Date: September 11, 2024

Project: Courtice Mixed Use Seniors Development at 1697 Highway # 2

Addendum No. 1

Mechanical Addendum No. M1

5TH FLOOR HVAC LAYOUT

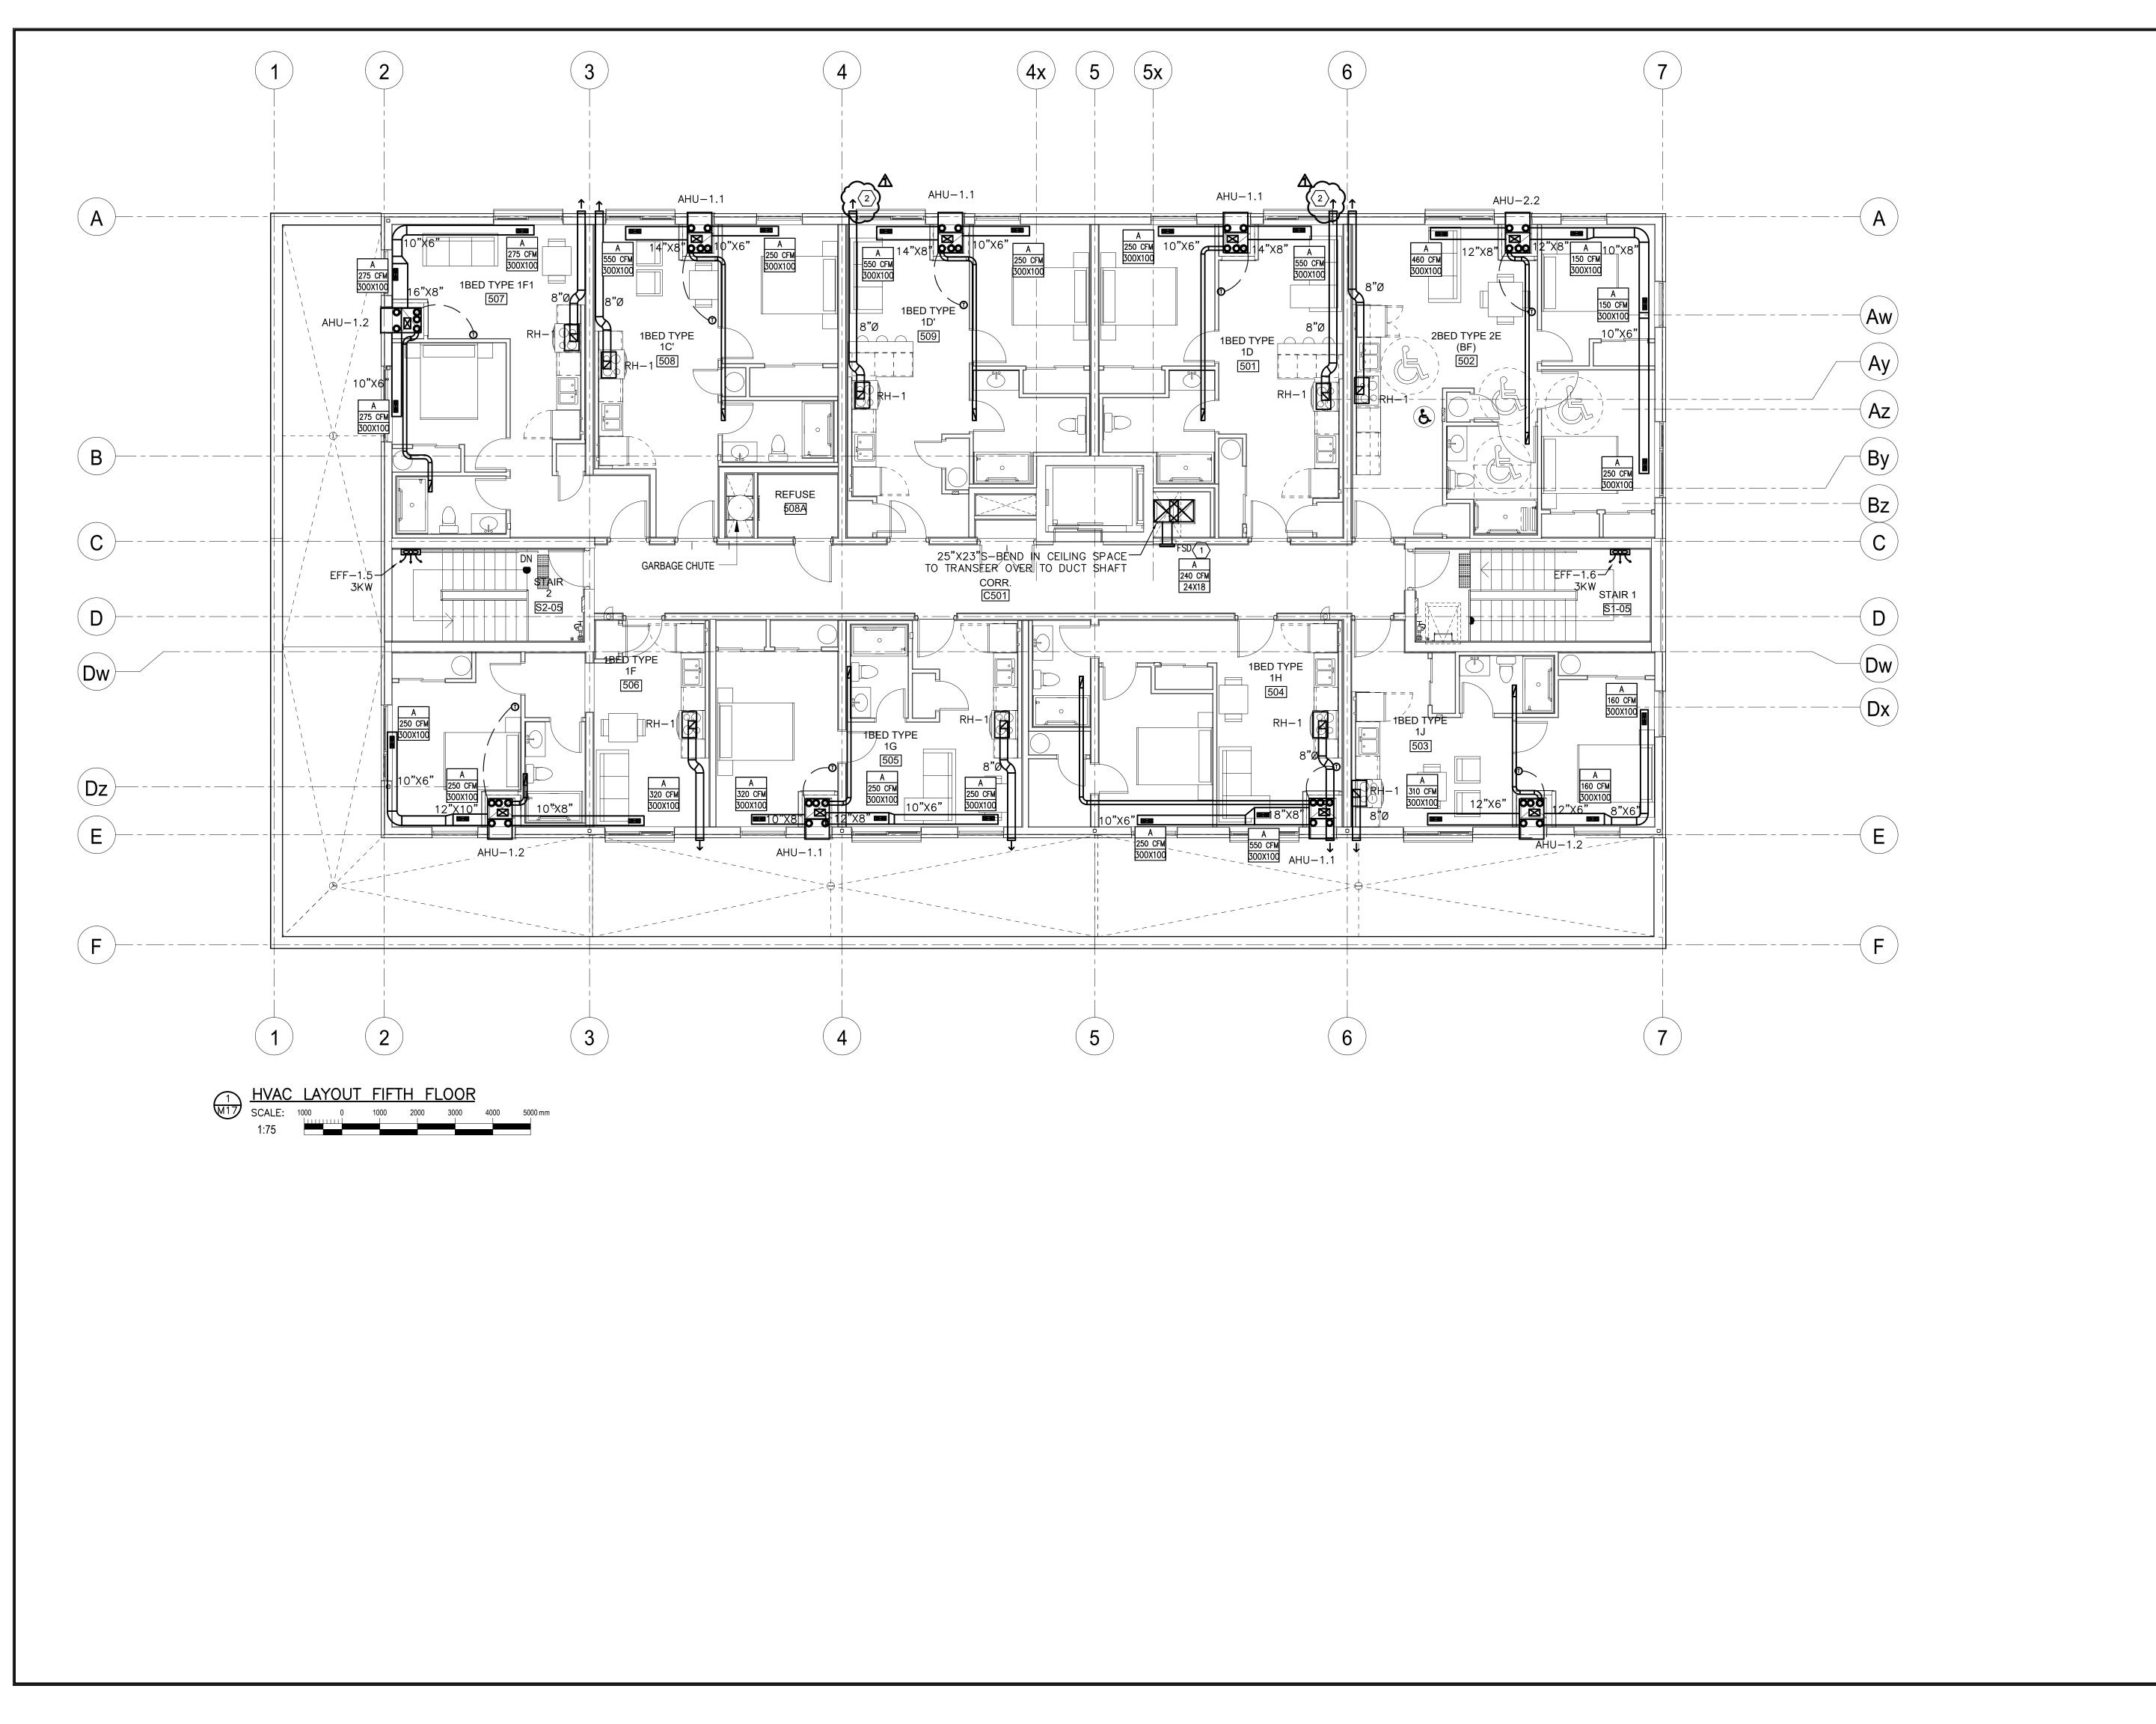
.1 Duct Layout Revision. Refer to Kirkland Engineering Ltd.'s Drawing No. M17 dated September 9, 2024.

- 1. Some suite range hood exhaust routing adjusted to coordinate with lintel. Changes bubbled on drawing.
- 2. Some suite ERV return ducting adjusted to fit in bulkhead (by architectural). Changes bubbled on drawing.
